UNITED STATES PATENT AND TRADEMARK OFFICE

APPLICATION NO.	FILING DATE	FIRST NAMED INVENTOR	ATTORNEY DOCKET NO.	CONFIRMATION NO.
10/517,735	08/08/2005	Ian Richard Webb	3700.P0388US	5929

Office Action Summary

DETAILED ACTION

(Straub Figures 1-5)

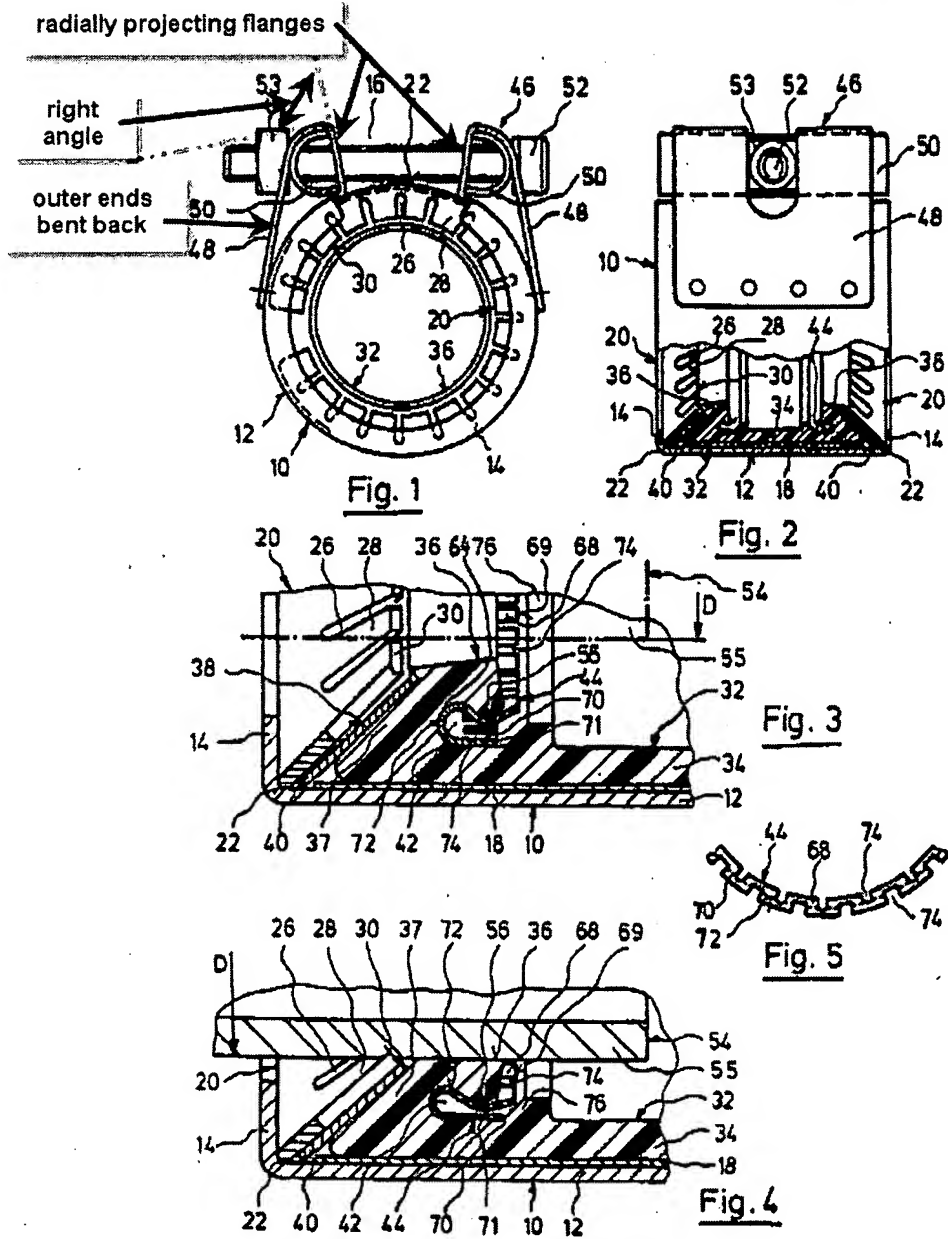
In regard to claim 10, Straub, in Figures 1-5, below, discloses a pipe coupling for connecting together the ends of two pipes, comprising:

a tubular casing (10) having circumferentially extending end flanges (14) projecting inwardly from the axial ends of the casing,

a tubular sealing sleeve (32) inside the casing;

tensioning (52 and 53) means for tightening the casing around the sealing sleeve; and

frustoconical gripping rings (44) located within the casing at opposite ends of the casing, the inner edges of the gripping rings being formed with teeth (68);

the casing comprising a strip of metal formed into a tube with a gap (as observed in Figure 1) extending longitudinally of the casing between the free ends of the strip;

wherein the free ends of the strip are bent outwardly to form radially projecting flanges extending longitudinally of the casing on opposite sides of the gap, the two radially projecting flanges being placed between two reinforcing members (50) which extend substantially the length of the coupling, the tensioning means passing through sets of aligned holes in the reinforcing members and the radially projecting flanges, the reinforcing members each having an angled cross-section (the reinforcing members are U-shaped - column 3, lines 8-9 - and, therefore, there is an angle formed by the junction of the straight sides and the curved portion as shown in Figure 1 cutout, below) of the , a web portion (shaded in Figure 1 cutout, below) through which the holes for the tensioning means pass, and a reinforcing flange extending along the longitudinal edge of the web portion that is nearer to the axis of the coupling, the reinforcing member flange bearing against the tubular portion of the casing (as observed in Figure 1, see Attachment A, the noted "reinforcing member flange" appears to abut the surfaces of the indicated corner. Simple contact meets a broad definition of "bearing").

In regard to claim 16, Straub further discloses that the aligned holes are elongated in the radial direction (as observed in Figure 2).

In regard to claim 17, Straub further discloses a backing rings (parts 40 in Figure 3, above) provided inside the casing adjacent a respective gripping ring (44) between the gripping ring and the sealing sleeve (32) to prevent the sealing sleeve from bulging between the teeth of the gripping ring.

(Straub Figure 1 cutout)

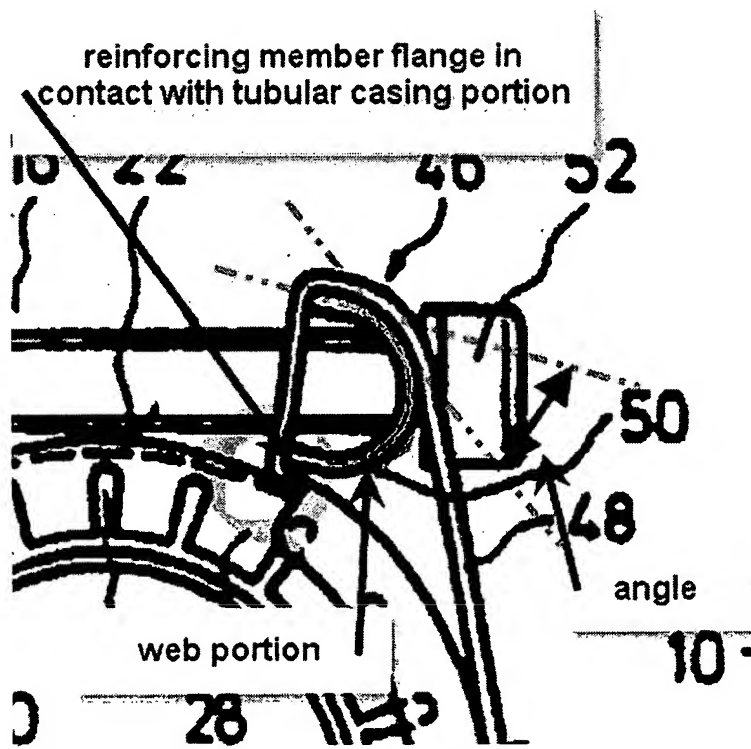
In regard to claim 11, as best understood, Straub further discloses that each reinforcing member has a channel-shaped cross section with reinforcing member flanges (the straight sides of the U-shape) extending transversely along both longitudinal edges of the web portion (as observed in Figure 1 cutout, above).

In regard to claim 19, Straub further discloses that the outer ends of the radially projecting flanges are bent back in a transverse direction to form planar stiffening flanges (as observed in Figure 1, above) along the longitudinal outer edges of the radially projecting flanges.

In regard to claim 20, Straub further discloses that the radially projecting flanges are bent back at right angles (as observed in Figure 1, above).

Fig. 1

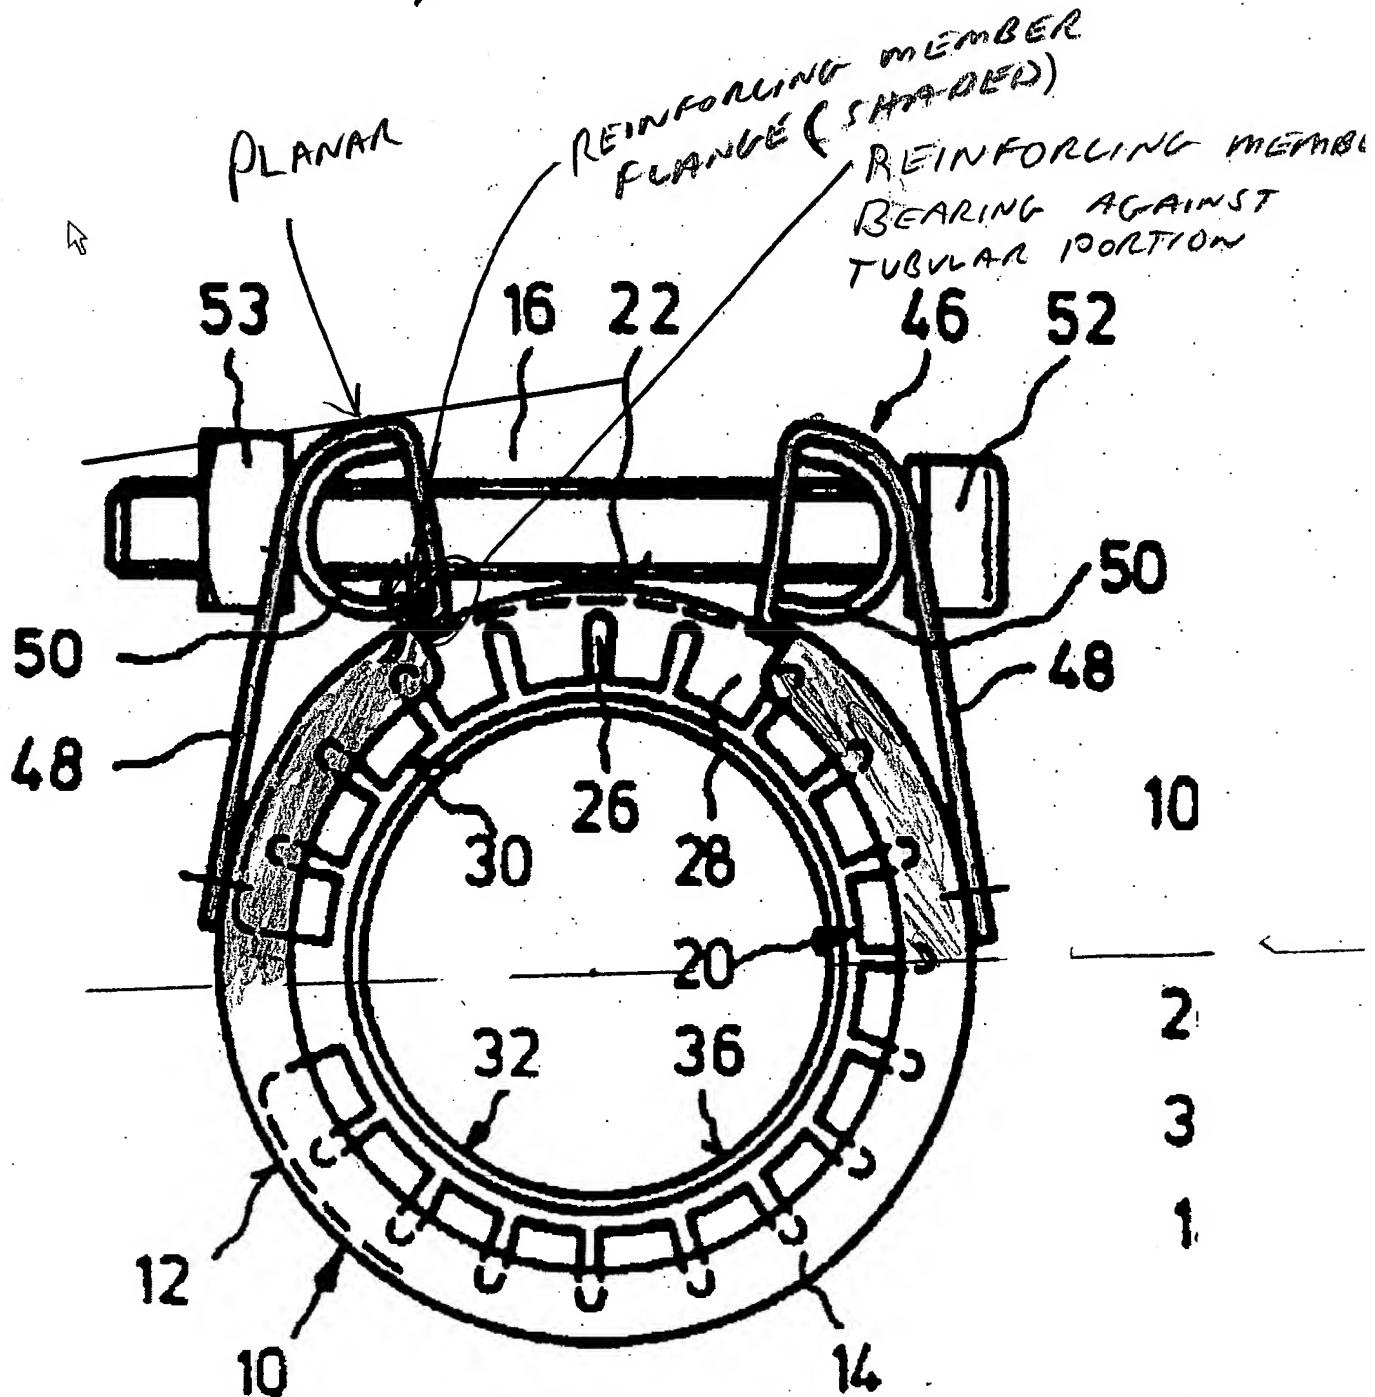
Concerning the Applicants' assertion in page 13, lines 4-6, of the reply filed 09/10/2007 that the prior art of Straub (U.S. 5,273,322) does not disclose a strip with a free end in regard to claim 10, the argument is not persuasive. The phrase "free end", given a broad definition, simply indicates an end that is free to move, not connected to the whole. The phrase "free end" indicates no specific structure and the phrase "free end" does not preclude any constituent structure, such as having loops. As shown in Figure 1, see Attachment A, the tubular casing of Straub does have two free ends, else how could the structure be tightened around two pipe ends? If the "free-end" of the prior art is not as the Applicants intended, then the Applicants should recite in the claims that structure which the Applicants do intend the phrase "free end" to indicate and thereby overcome the prior art of Straub.

Concerning the Applicants' assertion in page 13, lines 7-13 of the reply filed 09/10/2007 that the prior art of Straub (U.S. 5,273,322) does not disclose the reinforcing member flange bearing against the tubular portion of the casing. First, nowhere in the claim is it defined as to what constitutes the tubular portion of the casing; therefore, any arbitrarily portion that is a constituent of the tubular casing may be deemed to meet the "tubular portion" limitation since the whole casing, including any constituent elements and portions, is recited as being "a tubular casing" in claim 10, line 2. Further, as observed in Figure 1, see Attachment A, the noted

“reinforcing member flange” appears to abut the surfaces of the indicated corner. Simple contact meets a broad definition of “bearing”.

Concerning the Applicants' assertion in page 13, lines 7-13 of the reply filed 09/10/2007 that the prior art of Straub (U.S. 5,273,322) does not disclose the outer ends of the radially projecting flanges “bent back to form ‘planar stiffening flanges’”, the argument is not persuasive. As can be clearly observed in Figure 1, see Attachment A, the outer ends of the radially projecting flanges are “bent back to form ‘planar stiffening flanges’”.

SHADED AREAS ARE "FREE ENDS"
